RESPONSE TO REQUEST FOR ADDITIONAL INFORMATION

APR1400 Design Certification

Docket No. 52-046

RAI No.: 401-8402
SRP Section: 19.03 – Beyond Design Basis External Event (APR1400)
Application Section:
Date of RAI Issue: 02/08/2016

Figure 1. Pressure transients (loss of RHR at mid-loop operation)

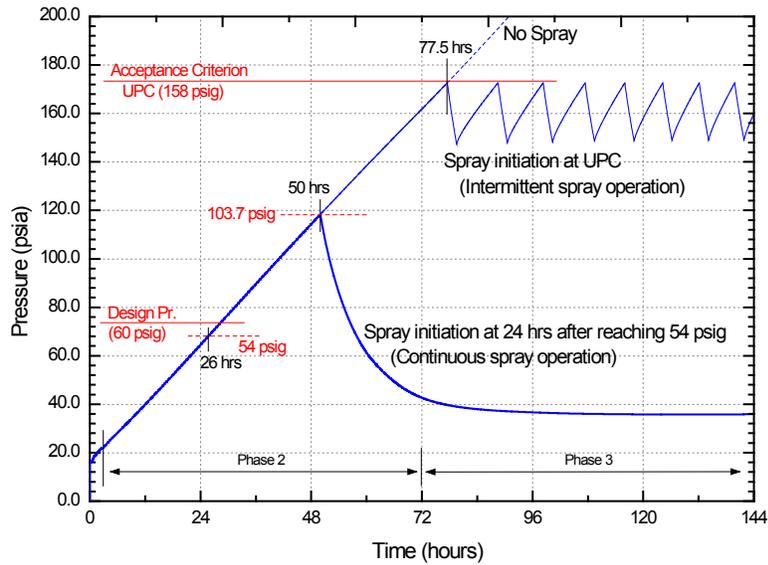
6. Provide justification that the instrumentation (e.g., pressure, temperature, level) credited with assisting the operators to maintain containment capabilities are qualified to function and provide reliable indication to the operator when exposed to these acceptance criteria. In addition, the staff requests that the applicant document the alarms, indications, and associated instrumentation that will direct the operator to initiate the emergency containment spray backup system (ECSBS).

7. Discuss how the uncertainty in the containment pressure displayed to the operator is considered in the analysis that provides the basis for operator actions to run the ECSBS in order to prevent the UPC limit from being exceeded.

Figure 1 and Figure 2 show the pressure and temperature transients of the case that uses the time duration of 24 hours after reaching the containment pressure of 54 psig (3.8 kg/cm²) for the spray initiation in comparison to the case that uses the UPC value as the pressure limit.

As shown in Figure 1, the containment pressure rises up to 103.7psig (7.3 kg/cm²) at 50 hours until the spraying begins. With the new scheme, the predicted highest pressure remains far less than the UPC limit, and which is even below the Factored Load Category (FLC) of 108 psig (7.6 kg/cm²). Referring to figure 2, the containment temperature increases up to 326 °F (163 °C), however it is still bounded by the environmental qualification temperature of 360 °F (182 °C) for all of the safety related equipment within containment.

From the pressure transient of the improved ECSBS operation method (continuous spray after 24 hours from reaching containment design pressure), as shown in Figure 1, the predicted highest containment pressure (103.7 psig or 7.3 kg/cm²) is far less than the UPC limit (158 psig or 11.1 kg/cm²), which provides a margin enough not to need consideration of uncertainties associated with the instrumentation and human errors.

Figure 2. Temperature transients (loss of RHR at mid-loop operation)

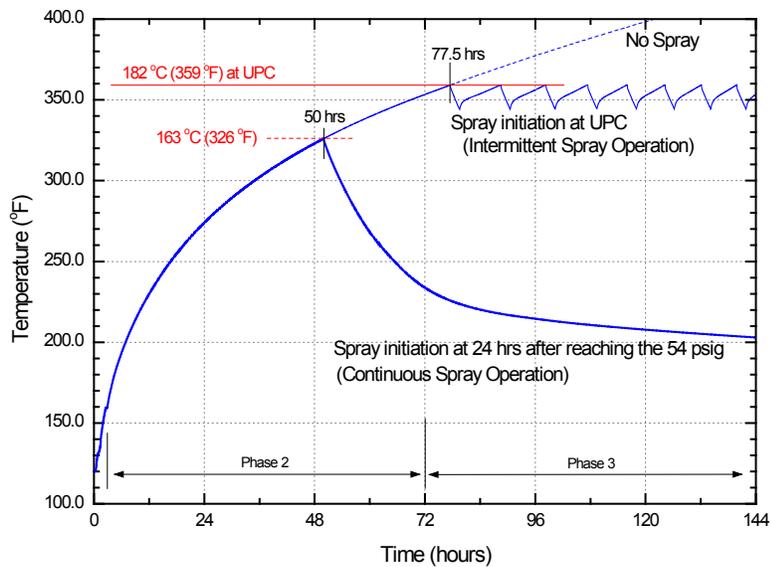
4. Evaluate if the predicted temperature in containment (185 °C or 365 °F) is bounded by the temperature at which the UPC limit (12.9 kg/cm² or 184 psia) was determined.

5. Provide the basis for why the containment temperature criterion of 185 °C (365 °F) (temperature associated with maintaining containment at the UPC limit) is acceptable to ensure containment capabilities are maintained.

All the instruments relative to core monitoring including the CET sensors and cables are qualified for temperatures above 360 °F (182 °C) which is the maximum temperature for environmental qualification (EQ) of the safety related equipment within the RCS as well as the containment. The EQ temperature is sufficiently high compared to the predicted highest temperature of 326 °F (163 °C), consequently ensuring normal operation of all instruments for core monitoring.

Figure 5-3 Containment Pressure for Full Power (RCP Seal LOCA)

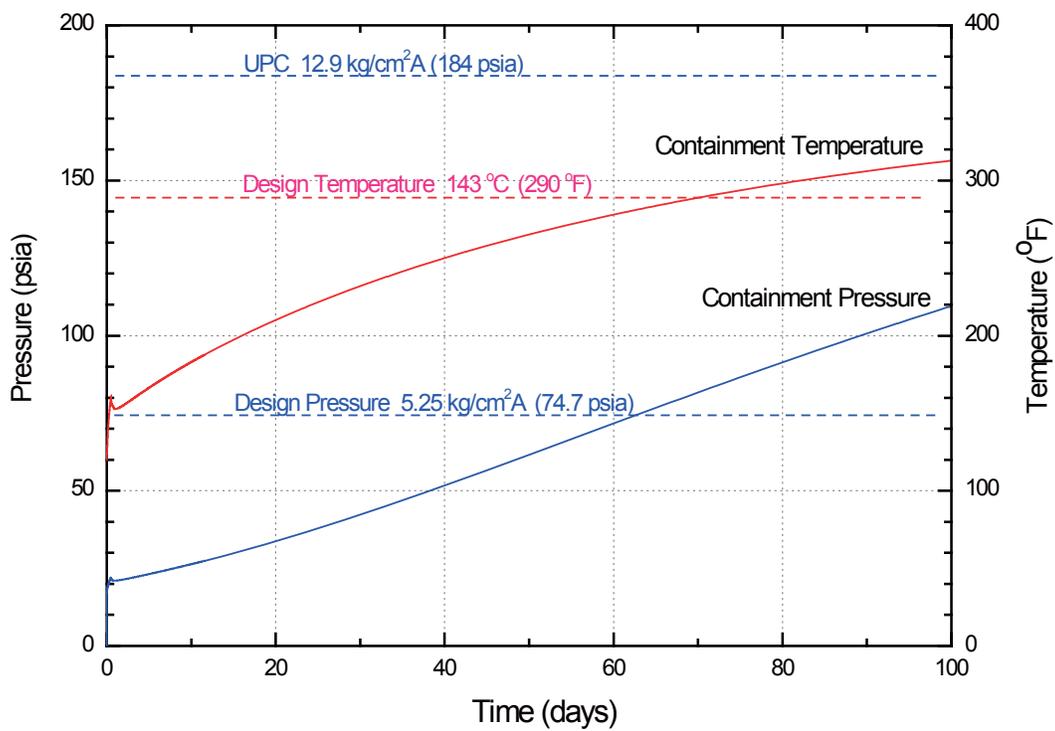
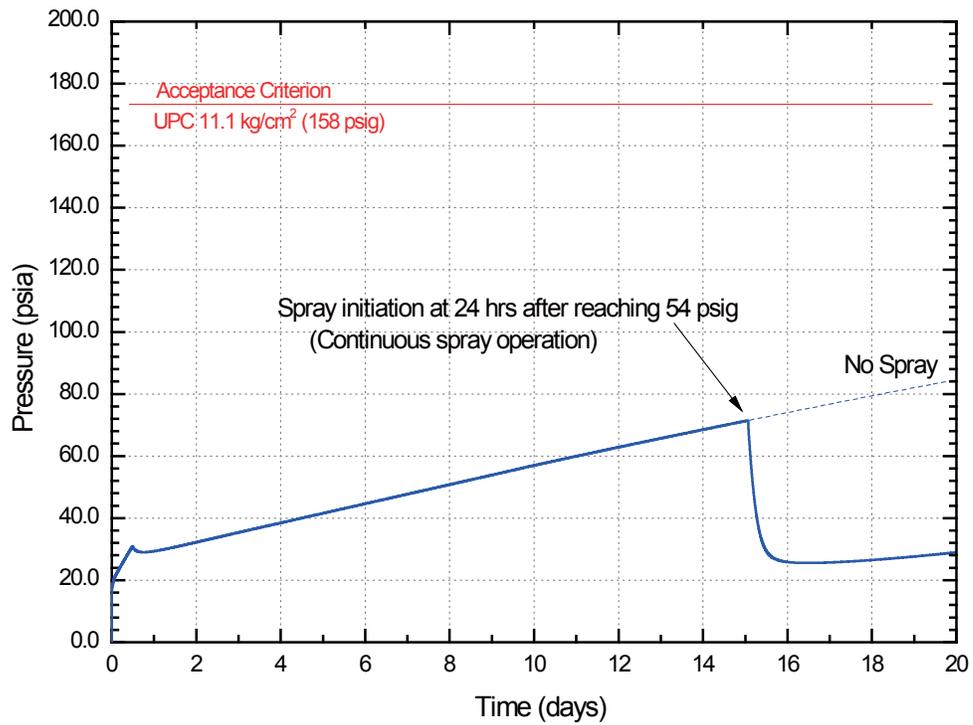
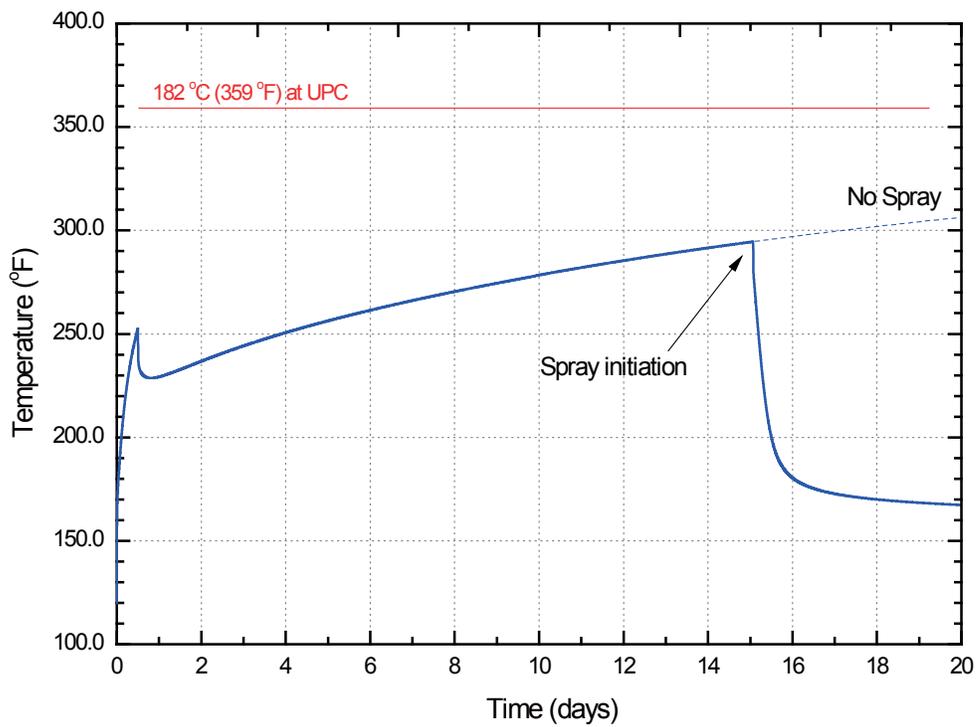
Replace with next two pages, D1, and D2

It is noted that the containment pressure is maintained well below the UPC limit at the RCP seal leakage following a BDBEE. Figure 5-3 and Figure 5-4 show the containment pressure and temperature transients to the RCP seal leakage, respectively.

~~Figure 5-4~~ Containment Pressure for Loss of RHR (Mode 5)

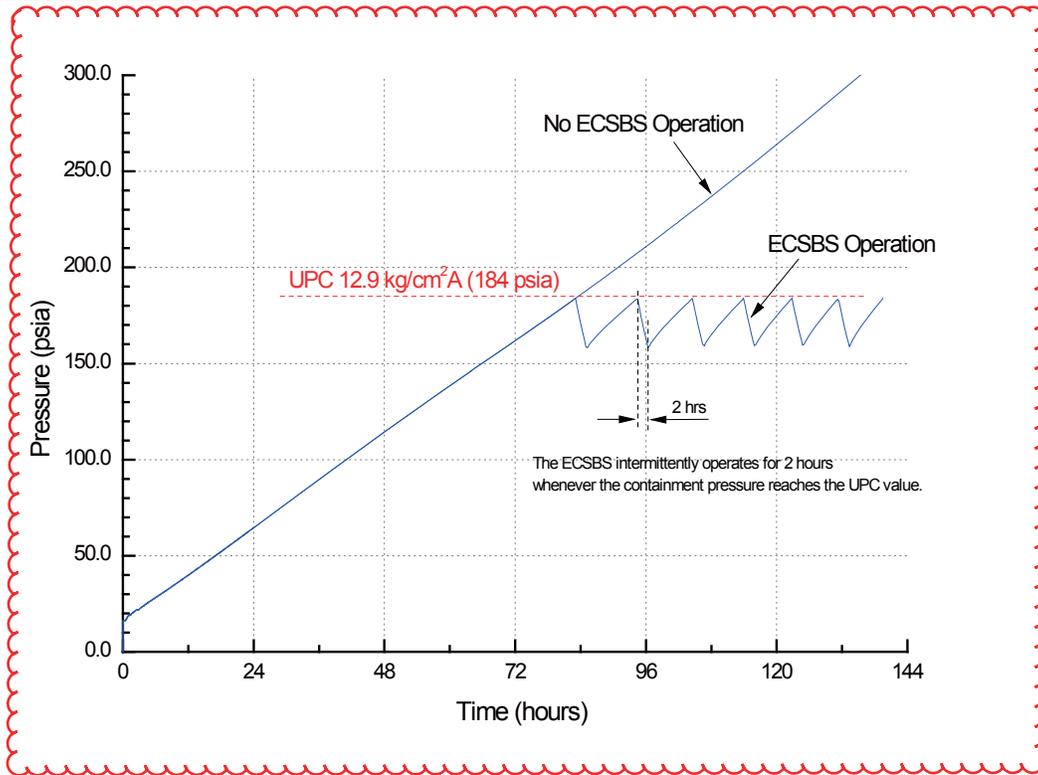
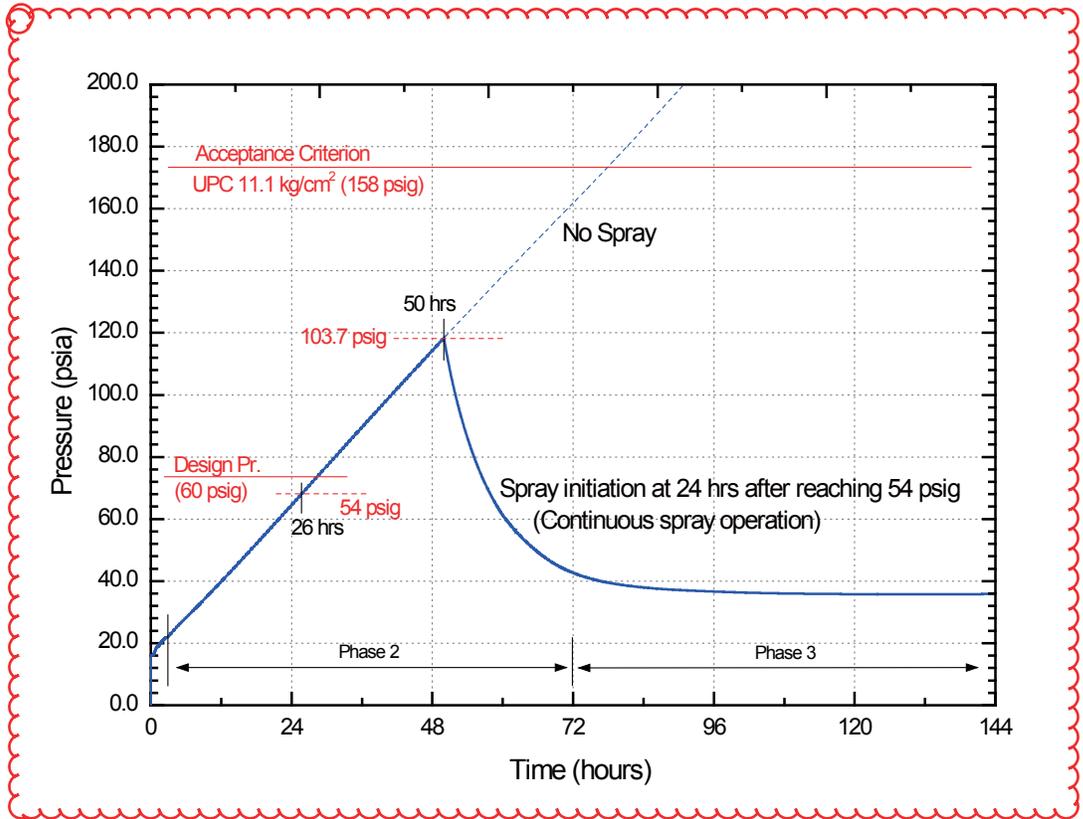
Replace with D3

The containment pressure increases up to 7.3 kg/cm² (103.7 psig) at 50 hours of the accident, however the predicted highest pressure remains far less than the UPC limit, and which is also below the Factored Load Category (FLC) of 7.6 kg/cm² (108 psig). The containment temperature reaches the highest temperature of 163 oC (326 oF), but which is well below the temperature limit of 182 oC (360 oF) for the environmental qualification (EQ) of the safety related equipment within the containment. Figure 5-5 and Figure 5-6 show the containment pressure and temperature results produced from the GOTHIC containment analysis.

Figure 5-5 Containment Temperature for Loss of RHR (Mode 5)

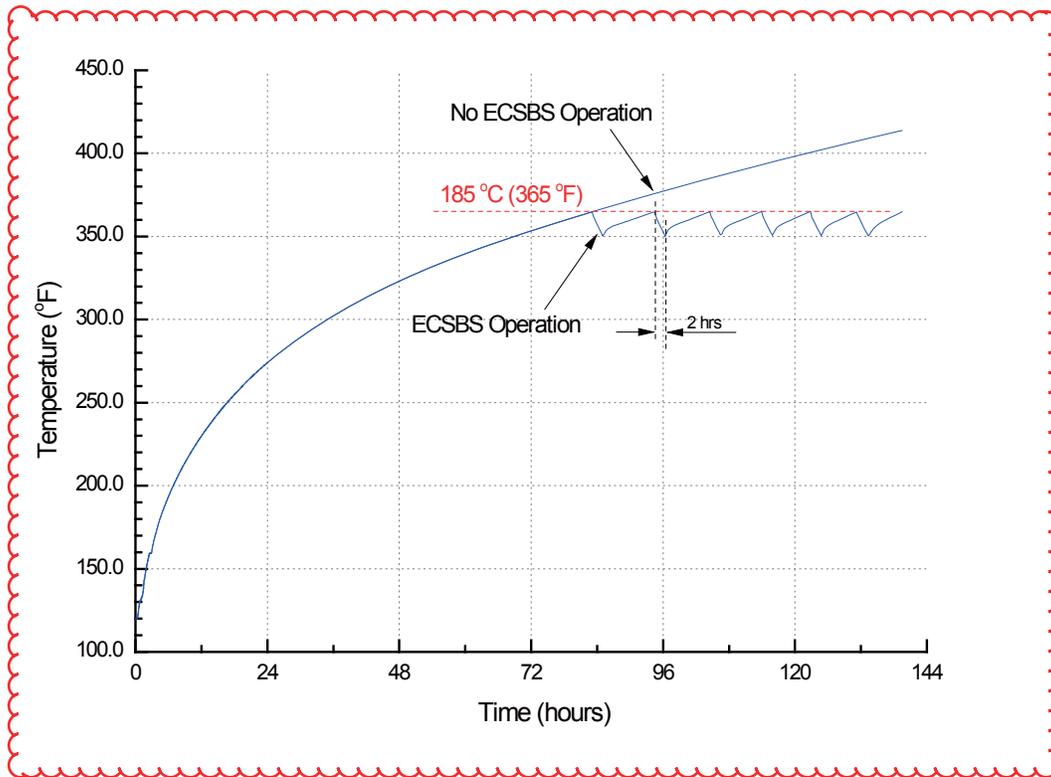
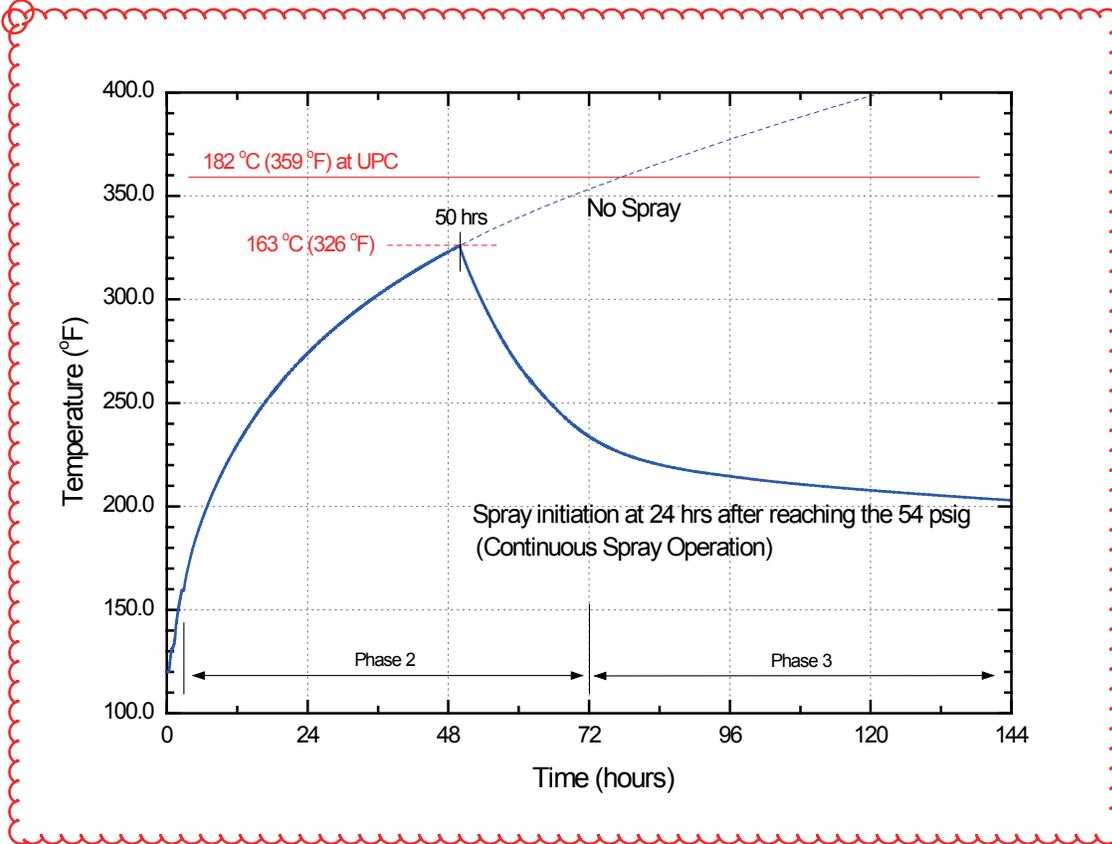
Replace with D4

Figure 6.2.2-1 Containment Spray System Flow Diagram

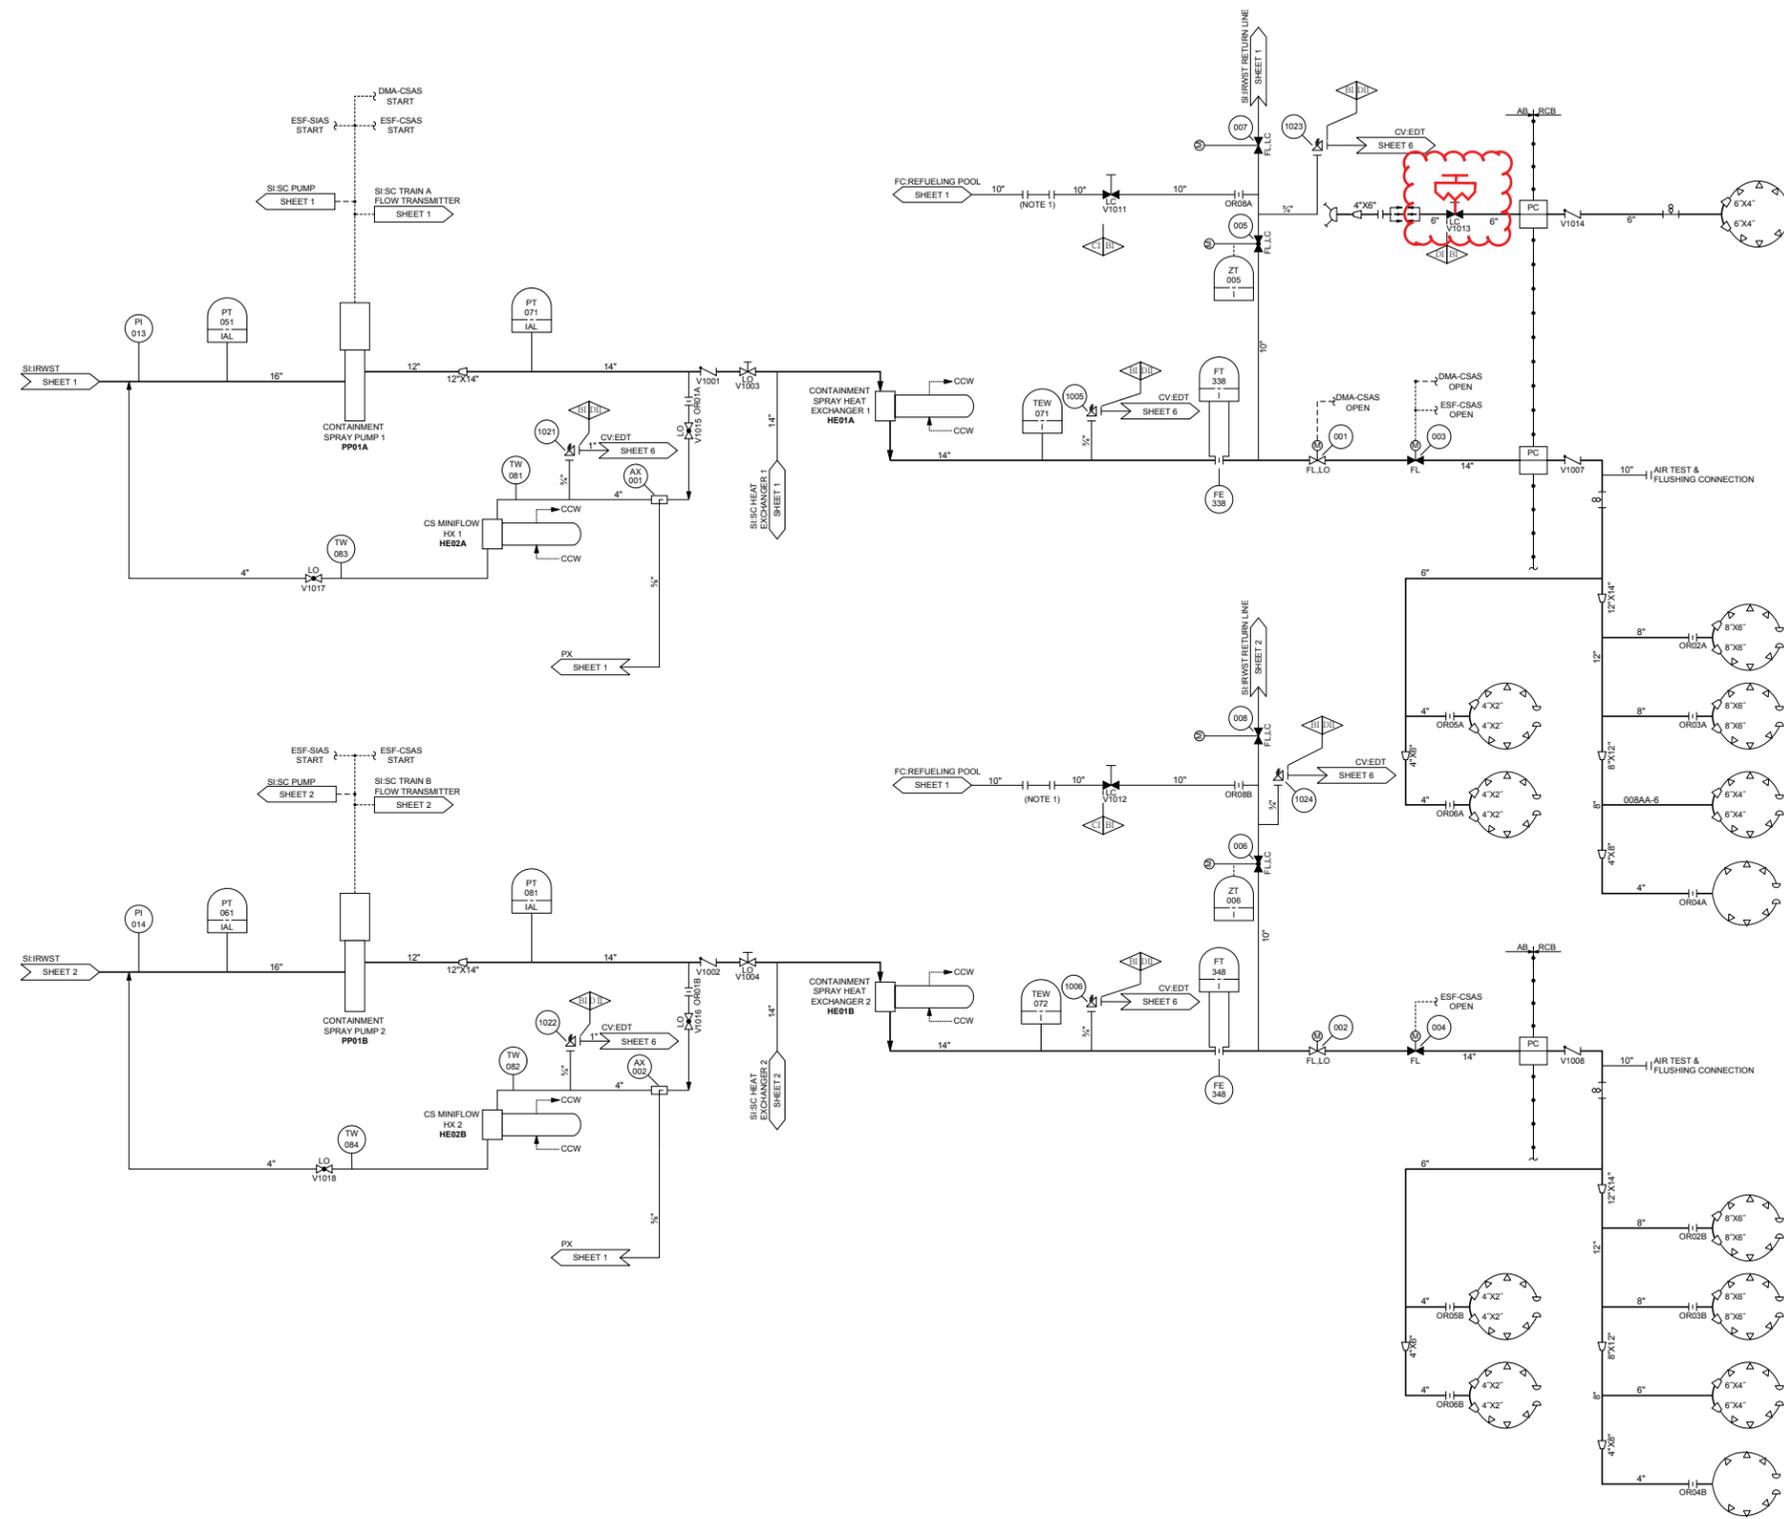
provide a listing of the areas requiring personnel access, the actions required (e.g., opening a valve, making a connection), and an evaluation of those areas to ensure the conditions will support the actions required by the plant-specific strategy for responding to the event. In addition, the staff requests that the applicant document the specific tasks required to initiate the emergency containment spray backup system (ECSBS) and the required time to establish ECSBS.

The specific tasks required to initiate the ECSBS and required time to establish ECSBS will be added to Technical Report APR1400-E-P-NR-14005-P/NP Subsection 5.1.2.5.2.3 as indicated in the Attachment. In addition, the DCD Tier 2 Figure 6.2.2-1 will be revised to incorporate the reach rod design of the ECSBS isolation gate valve (CS-V1013) which is to prevent the operator from entering the high radiation zone (see Attachment).

DCD Tier 2 Figure 6.2.2-1 will be revised as indicated in the Attachment.
